From: Belinda Ing <belinda.matthew.ing@gmail.com>
Sent: Friday, 7 September 2018 9:11 AM
To: Joel Herbert
Subject: Further objection to development proposals MP_07 0166 MOD 8

MP07_0166 Mod 8 is an application seeking to modify the Wahrenga Estate Concept Plan by providing detailed amended residential building envelopes and amended residential car parking rates for Precinct B: Central Church Precinct. The modification does not seek to alter the total maximum dwellings approved under the existing Concept Plan.

3.8 Solar Access

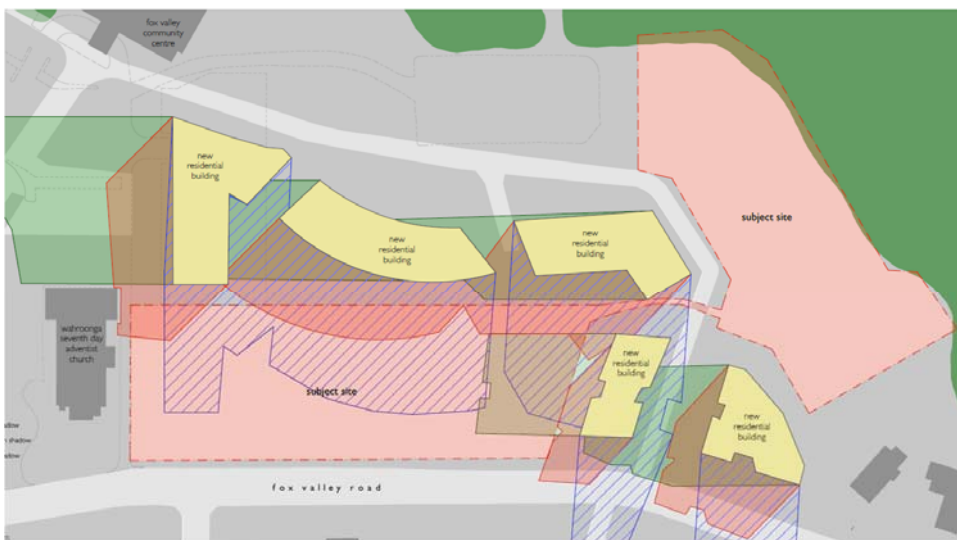
Whilst the amended plans, have amended the location of the building envelopes slightly, it can be seen from the above diagram that a large proportion of the school site will remain in shadow. Accordingly, it is considered that the concerns remain valid and the proposal will result in negative adverse impacts on the adjacent school site. The proposed Mod 8 application to increase the height planes and height limits of the buildings should not be approved and the detailed floor plans should also not be approved for the above reasons.
